ST. JOHNS RIVER WATER MANAGEMENT DISTRICT
ENVIRONMENTAL RESOURCE PERMIT #40-069-114354-1
RAI Submittal

HARTWOOD MARSH ROAD
PHASE II

**Re: Hartwood Marsh Road—Phase II
1500 feet East of Hancock Road to Orange County Line
Application Number 40-069-114354-1
Response to Request for Additional Information**

HARTWOOD MARSH ROAD – PHASE II 1500 FEET EAST OF HANCOCK ROAD TO COUNTY LINE DRAINAGE CALCULATIONS

HARTWOOD MARSH
ROAD - PHASE II

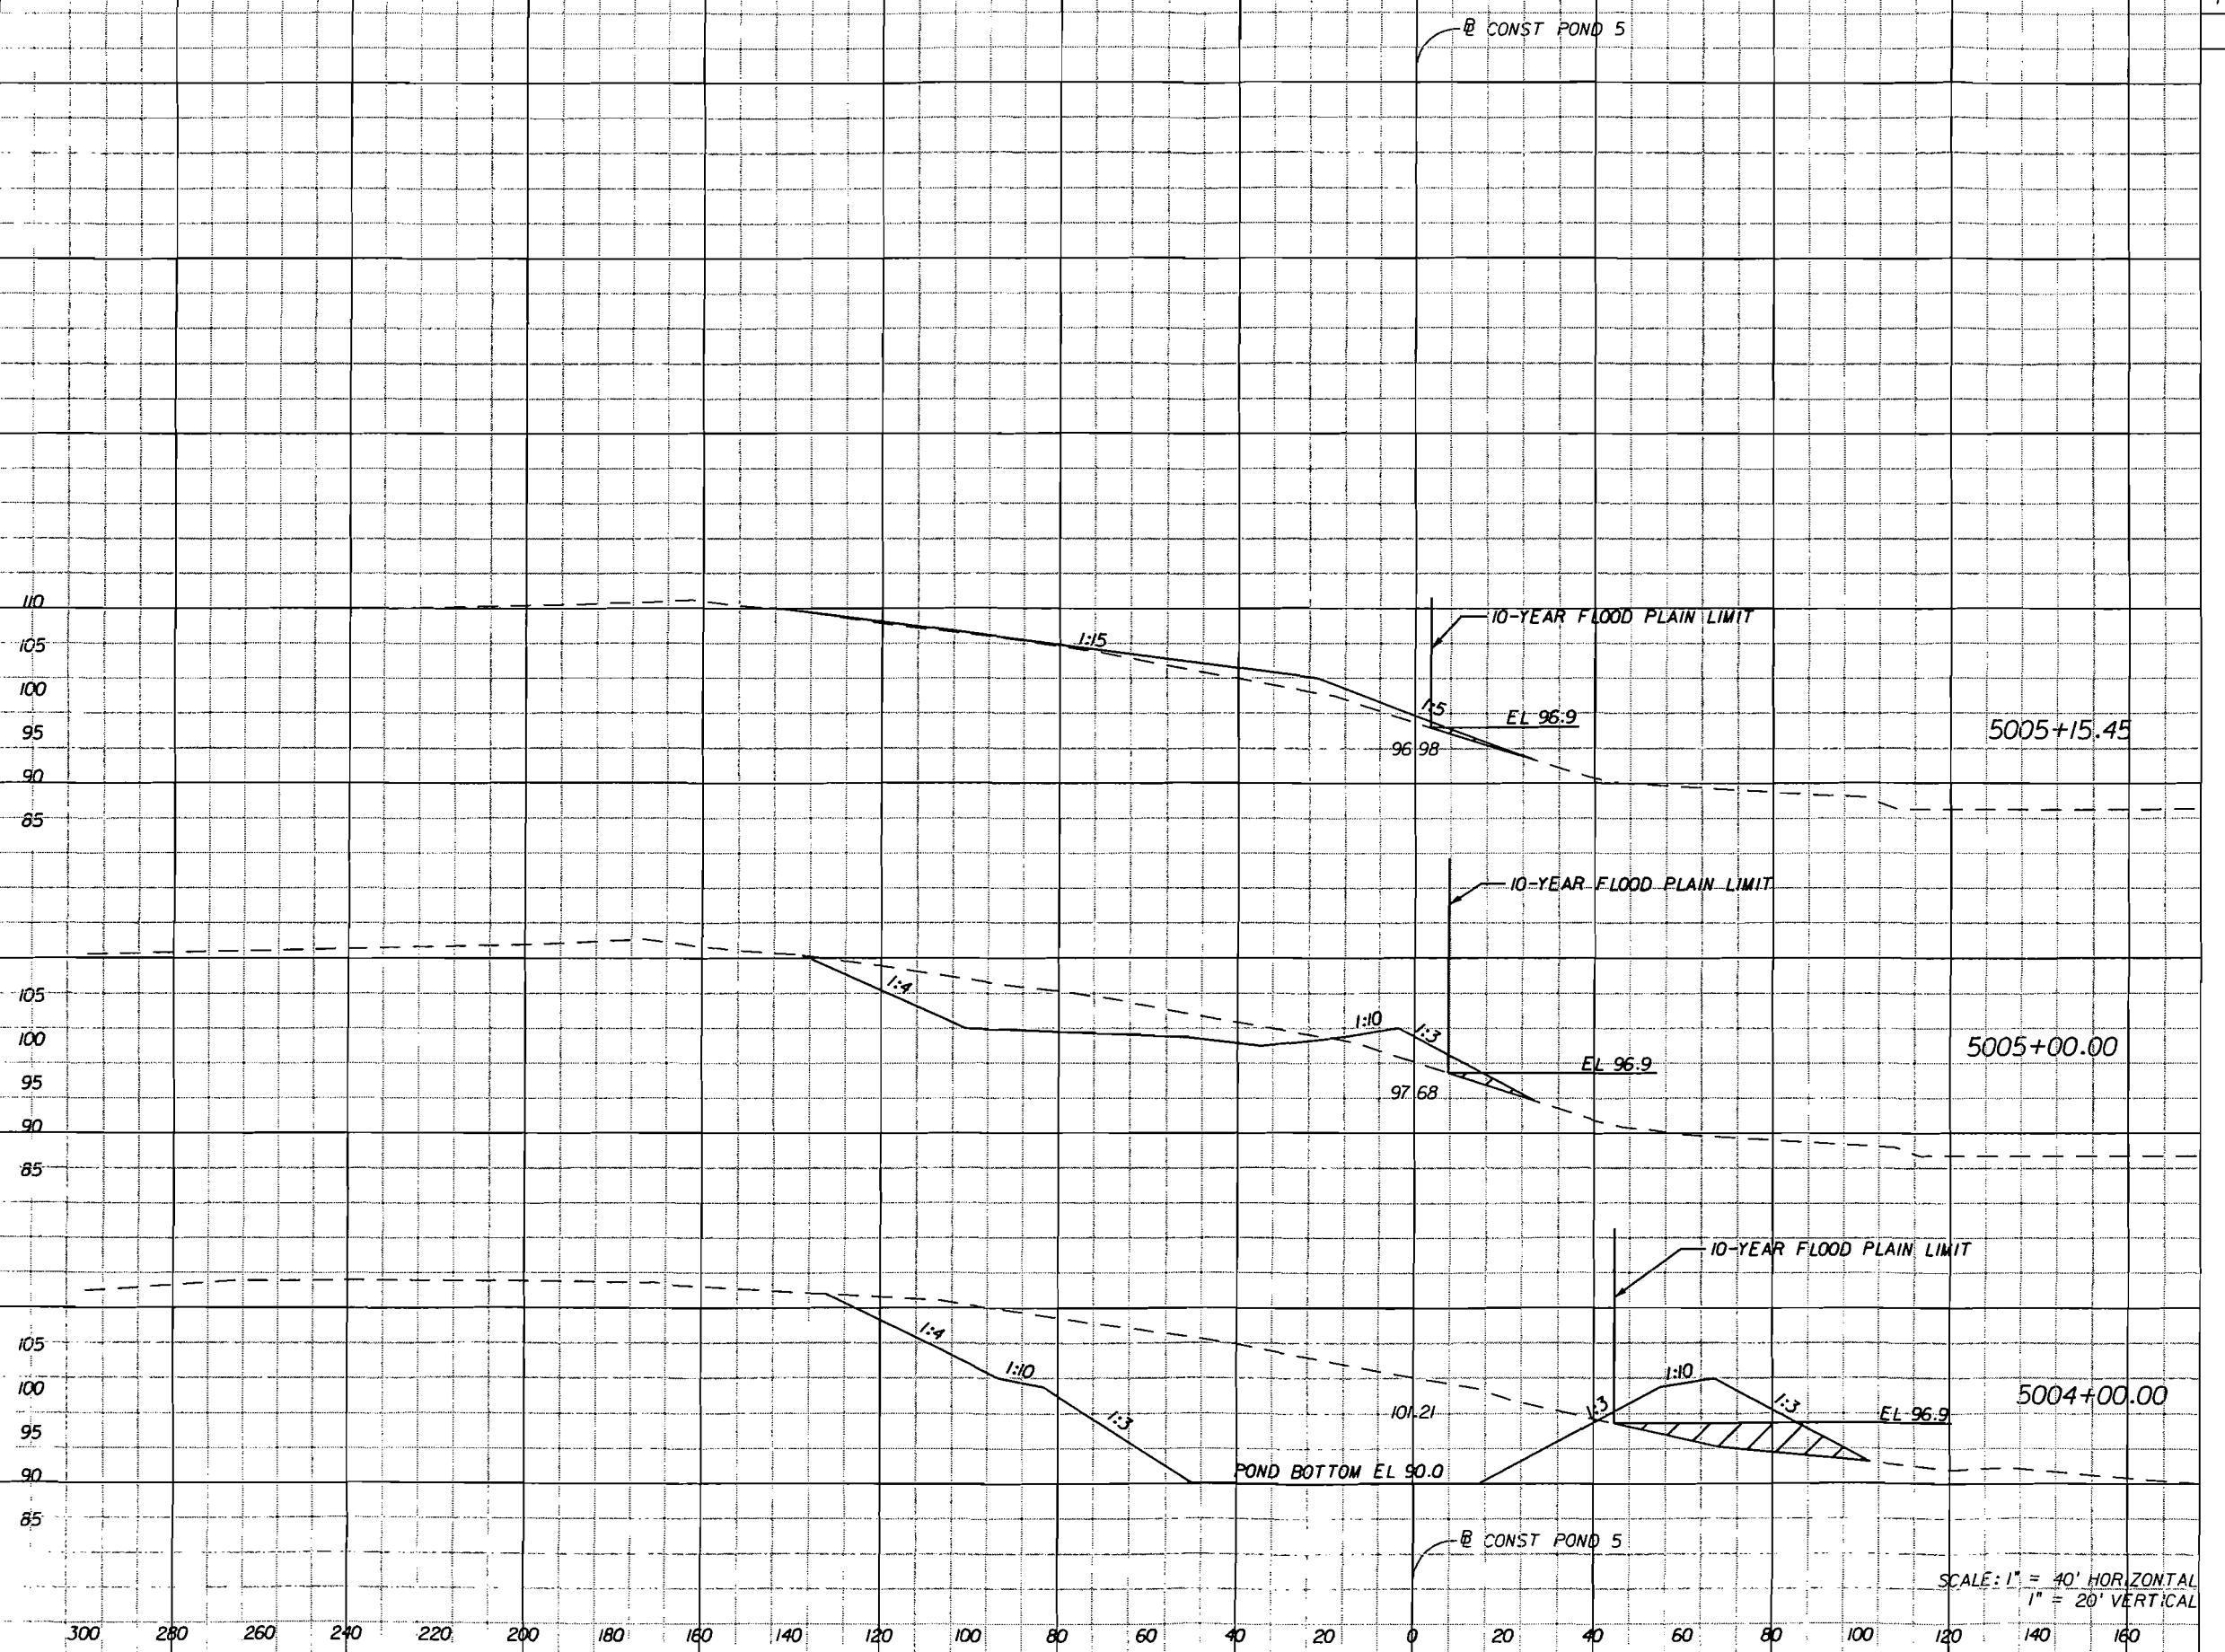
- c. The construction of a portion of the road and Pond 5 within Basin 5 will require the placement of fill in the 100-year flood plain for John's Lake. Insufficient information was provided; however, to determine whether impacts to the 10-year floodplain will occur and whether compensating storage will be needed. Accordingly, please provide additional calculations and/or documentation demonstrating that the proposed work will not cause a net reduction in flood storage within the 10-year flood plain pursuant to Section 10.5, Applicant's Handbook: Management and Storage of Surface Waters (A.H.: MSSW).

- Response:**
- a. *The stage-area input parameters in PONDS has been corrected. Please refer to the revised recovery calculations in the Appendix.*
 - b. *The volume for the 25-year/96-hour storm is 13.40 ac-ft. Please refer to the Hydrology Time Series report in the ICPR section of the Appendix for Pond 5. The back-to-back storms were run for Pond 5 and the pond will not overtop. Please refer to the stage-storage-volume sheet in the Appendix for Pond 5.*
 - c. *The 10-year floodplain calculations and cross sections have been included in the revised calculations in the Appendix. The amount of fill is less than the amount of excavation for the 100-year and 10-year; therefore, there is no net reduction in flood storage area for either storm. Please refer to the 10-year floodplain calculations in the Appendix for Pond 5 as well as the revised cross-sections for the 10-year floodplain.*
